CREEKVIEW
EAST PARKING
LOT

SITE PLAN

CASE FILE #PL201800241

GRADING
PLAN

C2-1

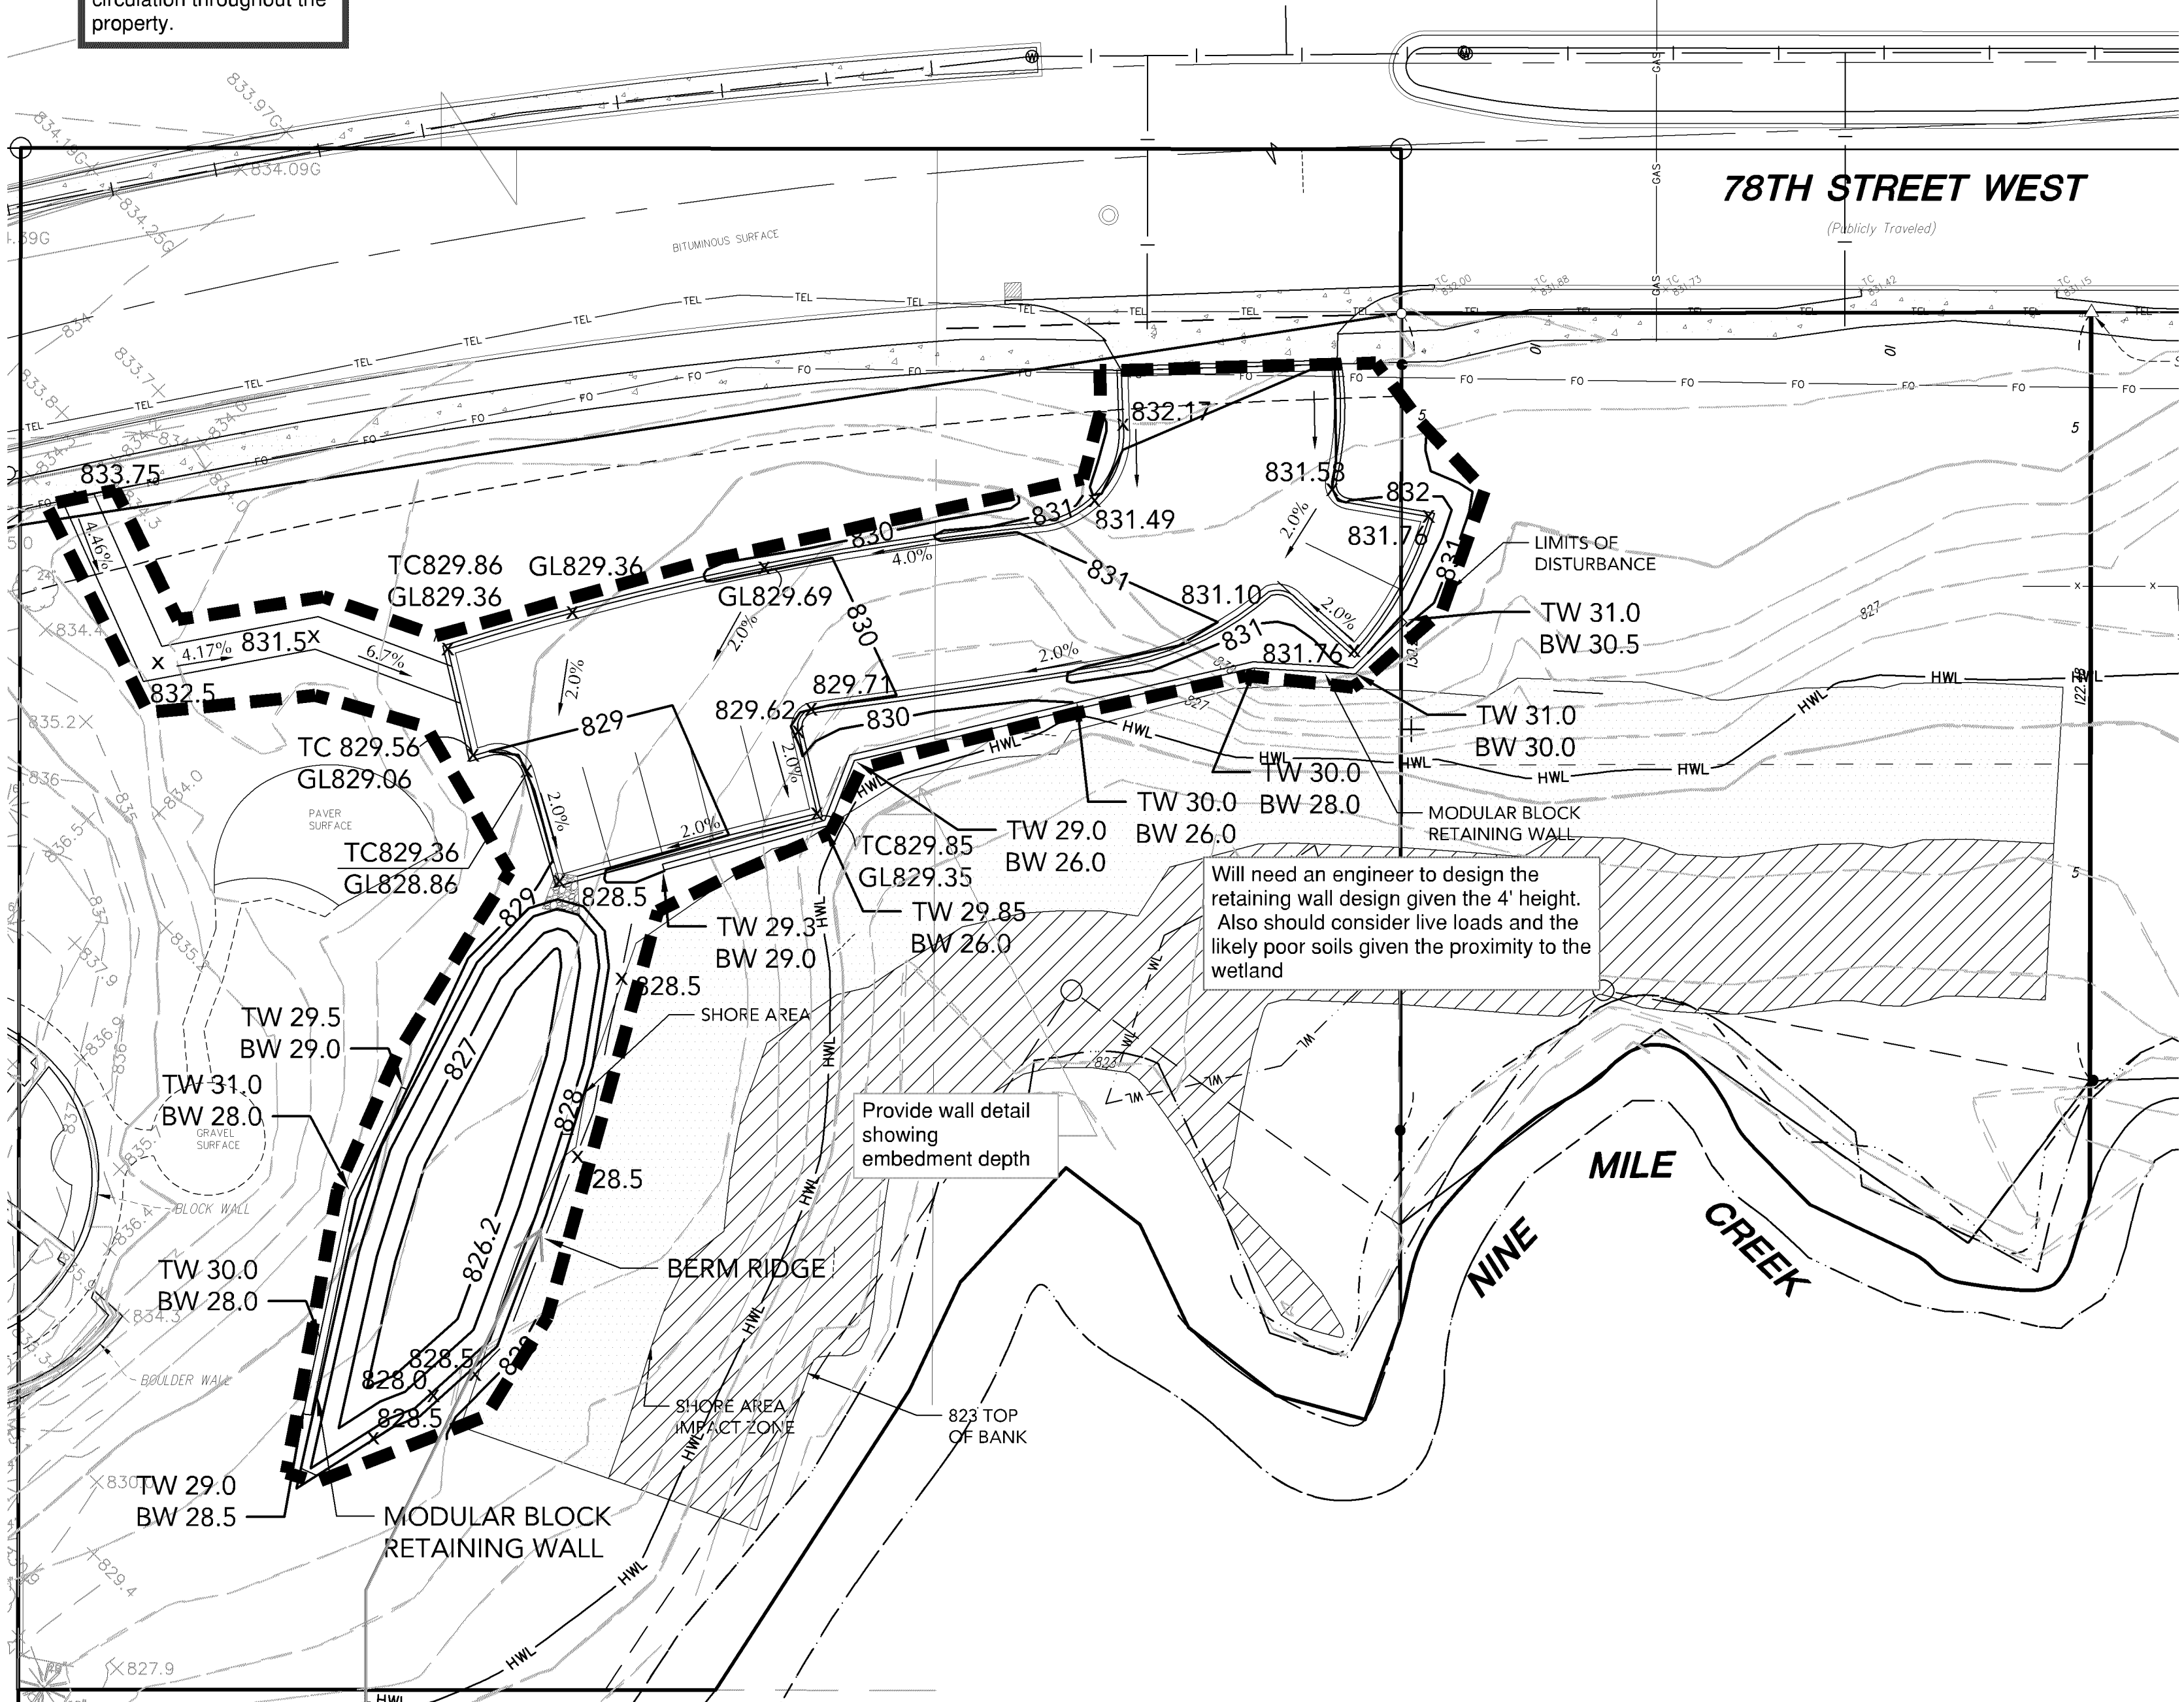
Per Section 21.301.06(c)(2)(C) of the City Code, minimum parking stall size for 90 degree surface parking is 9' x 18'. Compact parking may be allowed per Section 21.301.06(c)(2)(C)(iii).
7. ALL CURB RADII SHALL BE 5.0' UNLESS OTHERWISE NOTED.
8. BITUMINOUS IMPREGNATED FIBER BOARD TO BE PLACED AT FULL DEPTH OF CONCRETE ADJACENT TO EXISTING STRUCTURES AND BEHIND CURB ADJACENT TO DRIVEWAYS AND SIDEWALKS.
9. SEE SITE ELECTRICAL PLAN FOR SITE LIGHTING.
10. ALL PARKING LOT PAVEMENT MARKINGS SHALL BE 4" WIDE WHITE PAINTED STRIPING.

Signs should be placed on the private property and out of the public right-of-way. No sign should be located within the 2' clear zone along the sidewalk.

Maintain emergency vehicle access and circulation throughout the property.

Will need an engineer to design the retaining wall design given the 4' height. Also should consider live loads and the likely poor soils given the proximity to the wetland

Provide wall detail showing embedment depth

Shore Area Permit required for grading within the shore area per Section 19.87.04(b)(2) of the City Code.
